Notice of Modification

The project approval for the Collector Wind Farm (10_0156), granted by the Planning Assessment Commission, as delegate of the Minister for Planning, on 2 December 2013.

SCHEDULE 2

**ATTACHMENT 1
SCHEDULE OF LAND**

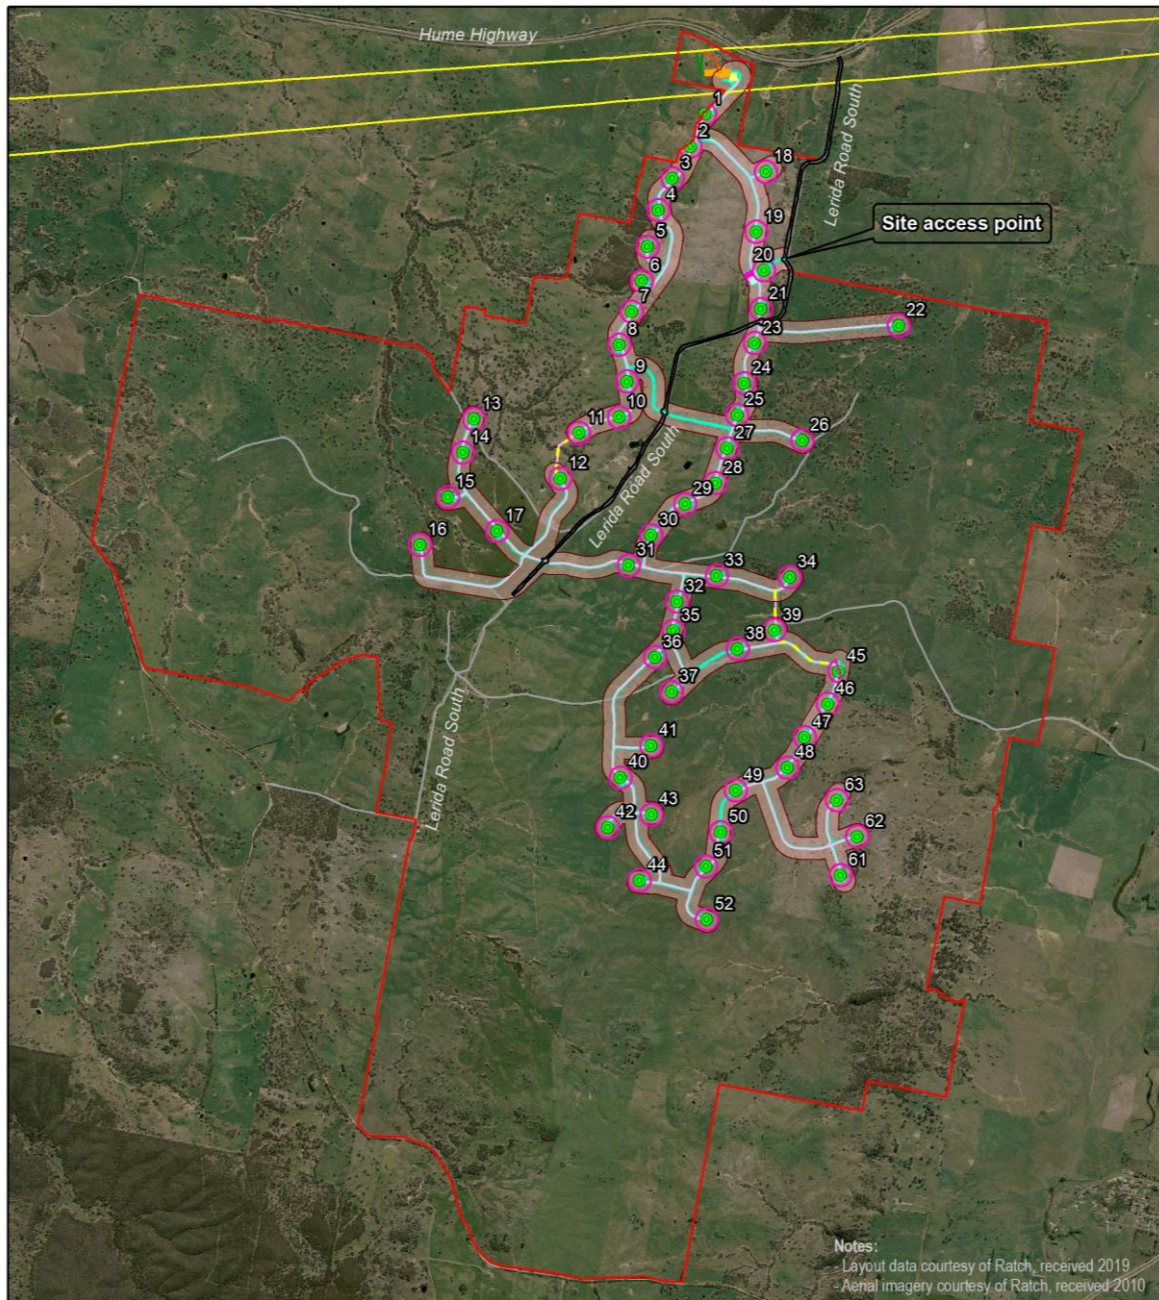
44. In Attachment 1, delete the heading '**ATTACHMENT 1**' and replace with '**ATTACHMENT 5**'.
45. Replace Attachment 1 with the following:

Note: The project site will also be taken to include any crown land, and any road reserves, contained within the project site.

Figure 1: Project layout

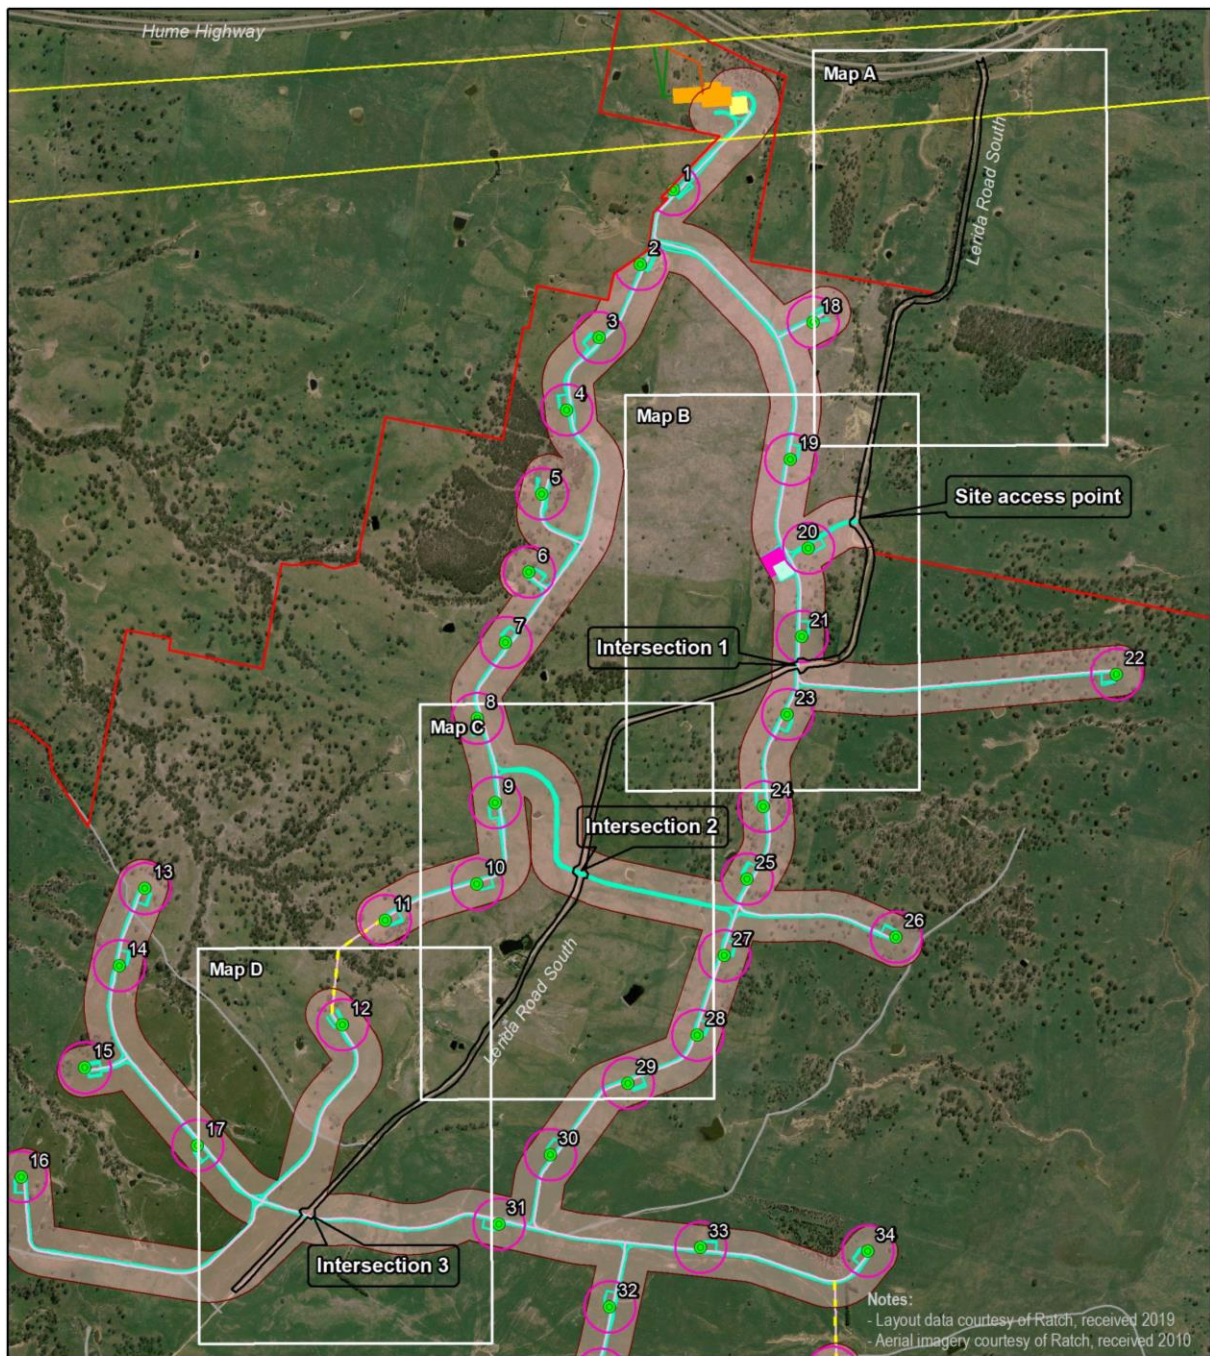
46. Delete the Project Layout figures in **ATTACHMENT 2** and replace with the following:

ATTACHMENT 3 ROAD UPGRADES

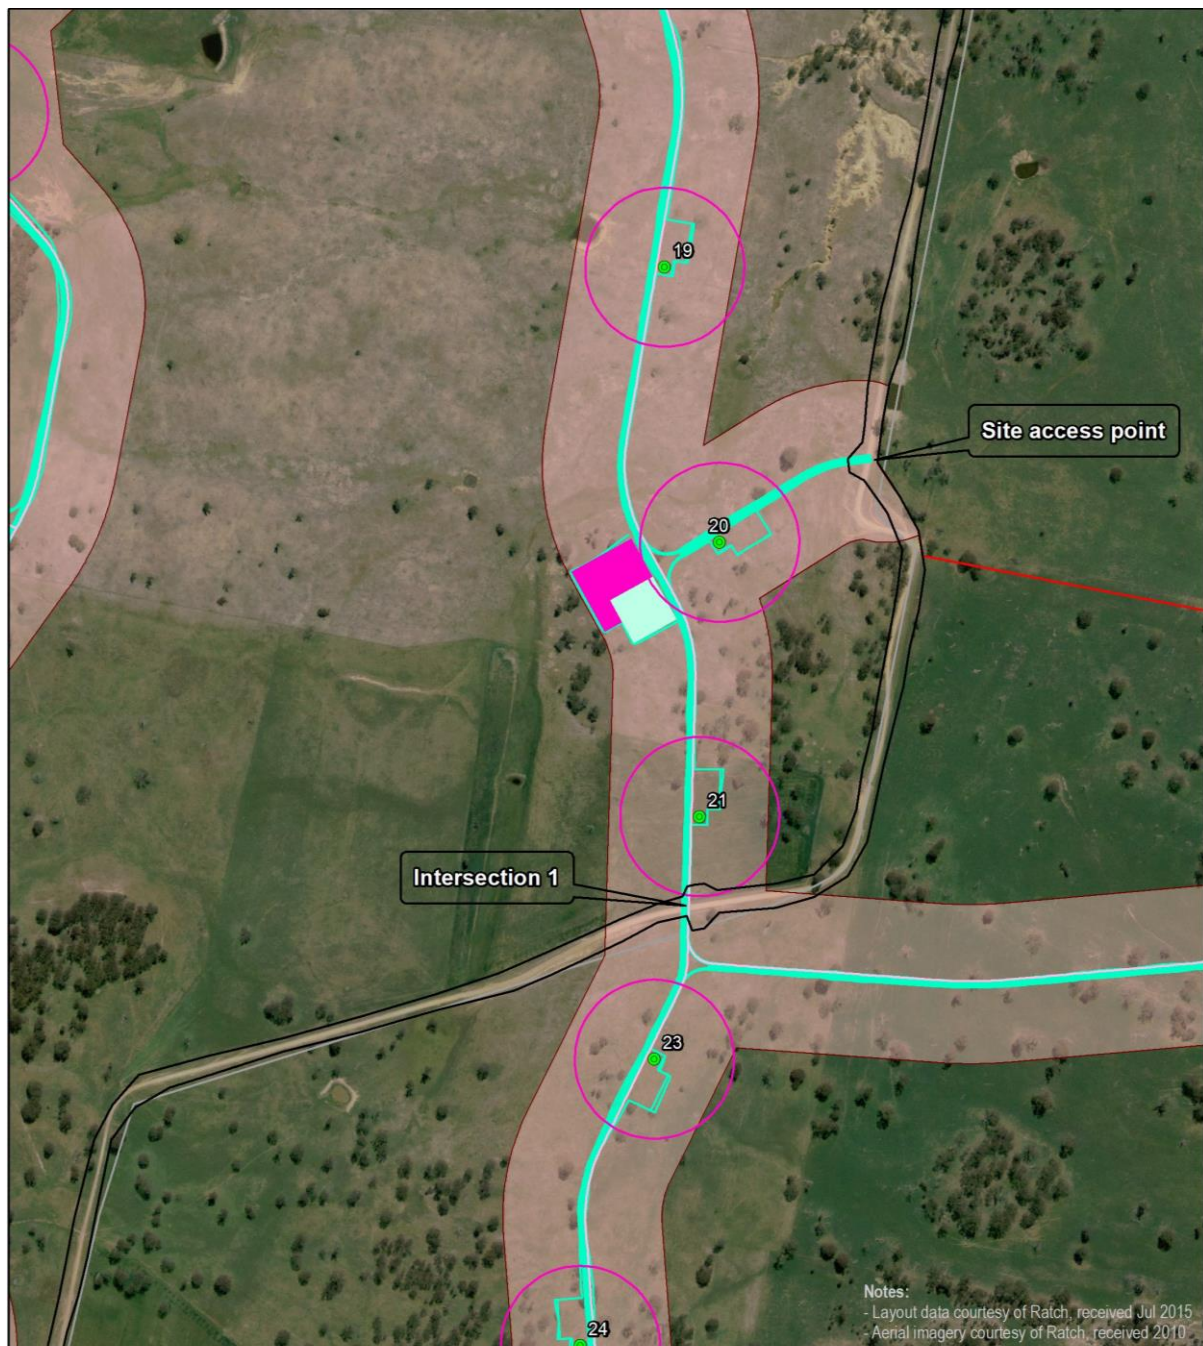
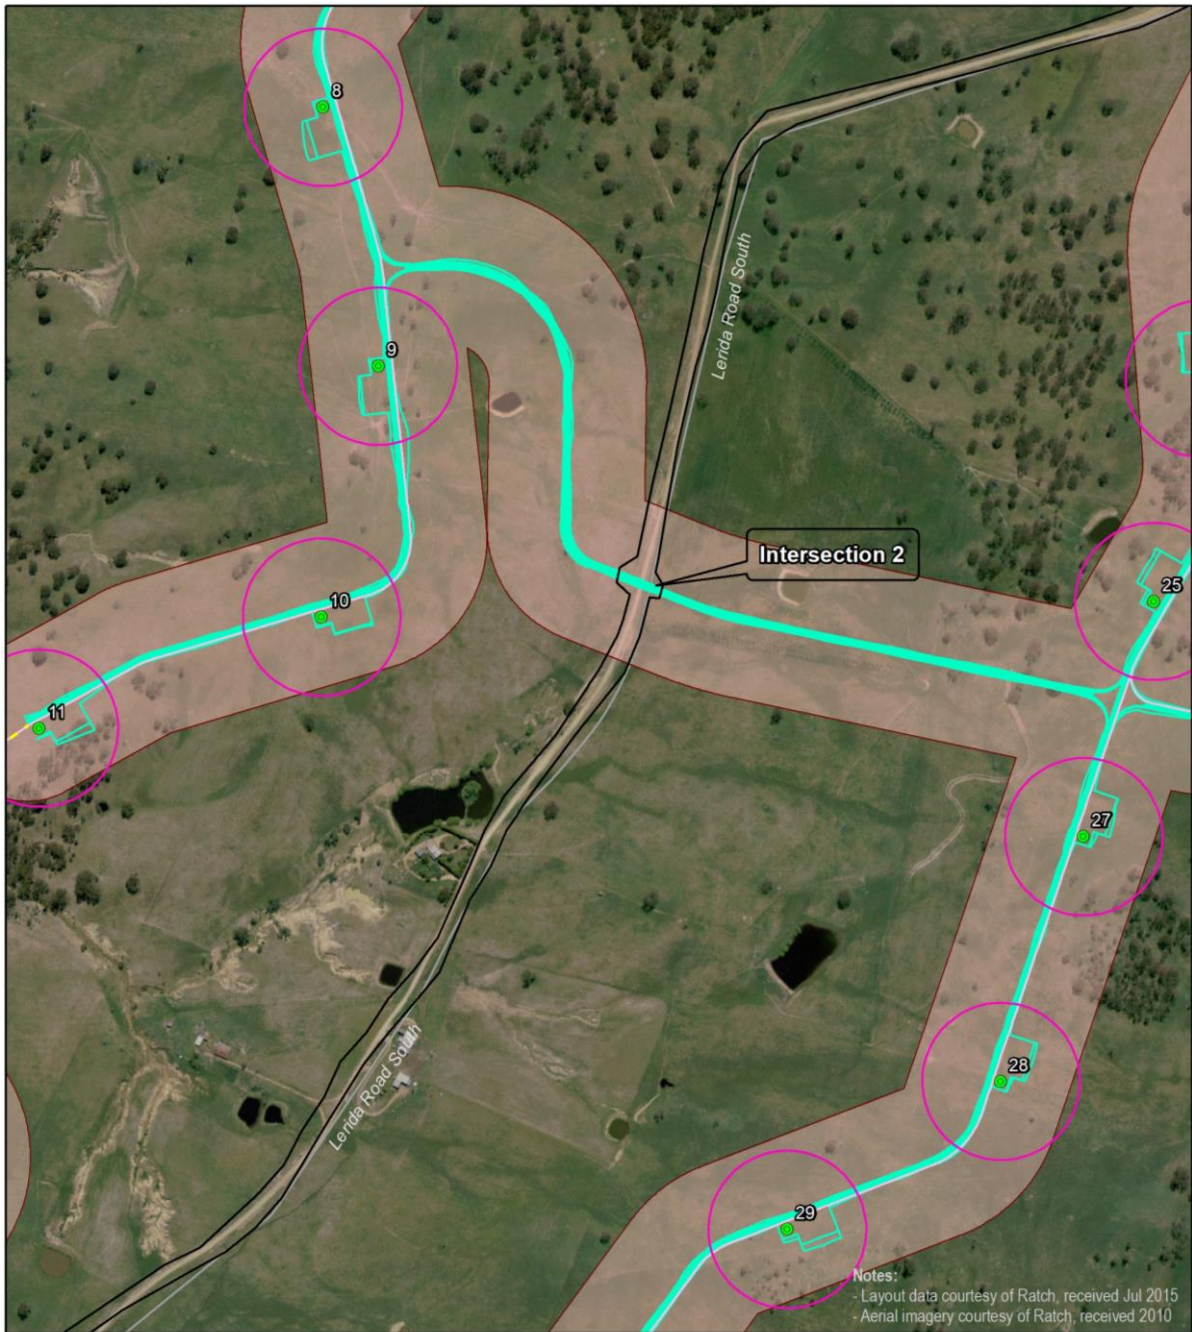
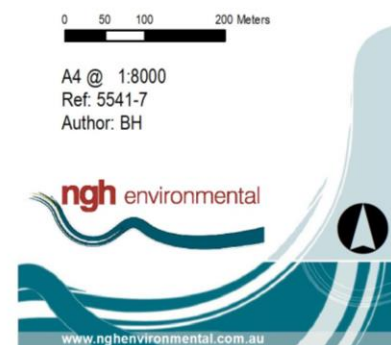
47. After **ATTACHMENT 2** , insert the following:

Road/Intersection	Start – End	Length (km)	Upgrade	Timing
Lerida Road South	Hume Highway to main site access point	2	- Sealing and widening including a 7.0 m seal and 8.0 m formation width - Installation of new fencing (or maintain existing fencing) along both sides of the road	Prior to commencing the use of Lerida Road South for any over-dimensional or heavy vehicle traffic associated with the construction of the project
	Main site access point to intersection 1	0.75		Prior to commencing the use of Intersection 1 or within 6 months of the commencement of construction, whichever comes first
	Intersection 1 to intersection 2	1.3		Prior to commencing the use of Intersection 2 or within 6 months of the commencement of construction, whichever comes first
	Intersection 2 to a point 250 m south of the intersection 3	2		Prior to commencing the use of Intersection 3 or within 6 months of the commencement of construction, whichever comes first

Lerida Road South / Site Access Points Intersection	-	-	Indented access at each of the site crossing points	Prior to commencing the use of the site access point intersection for any traffic associated with the construction of the project

- To identify the approximate location of the site access points and road upgrades, see the figures in Attachment 3 - Figure 3-A to 3-E.
- Under Part 4.42 of the EP&A Act, the Proponent is required to obtain consent under section 138 of the Roads Act 1993 from the relevant road authority prior to commencing the road upgrades.
- To avoid any confusion, heavy vehicles required for the road upgrades are permitted to use Lerida Road South for the purpose of the upgrades.
